Shanta Denims Ltd (10180)

Plot #156 & 177, D.E.P.Z., Ganakbari, Savar

28.APRIL.2014

Identified Priority 1 Concerns

Small square column in place of larger circular column & deficient reinforcing

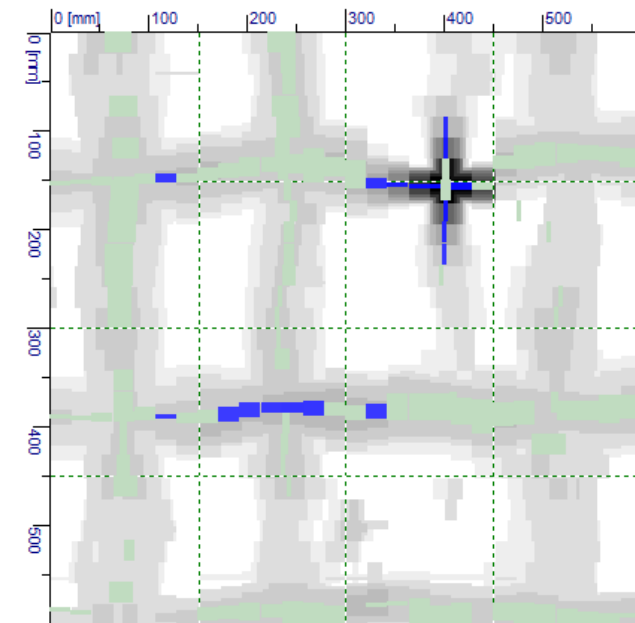
Numerous discrepancies between the construction and the structural plans were observed. Specifically concerning columns, we found in several instances, one 19" x 19" column with 12 vertical bars instead of the specified circular 24" dia column with 16 vertical bars. Regarding slabs, we measured 254 mm flat slabs at each level instead of 165 mm typical floor beam/slab shown by the drawings. The large degree of deviation from design drawings instills a great degree of uncertainty regarding the adequacy of construction to support the imposed loads.

- A Detailed Engineering Assessment (DEA) is to be commenced to assess the adequacy of the as-built construction of the East and West concrete buildings.
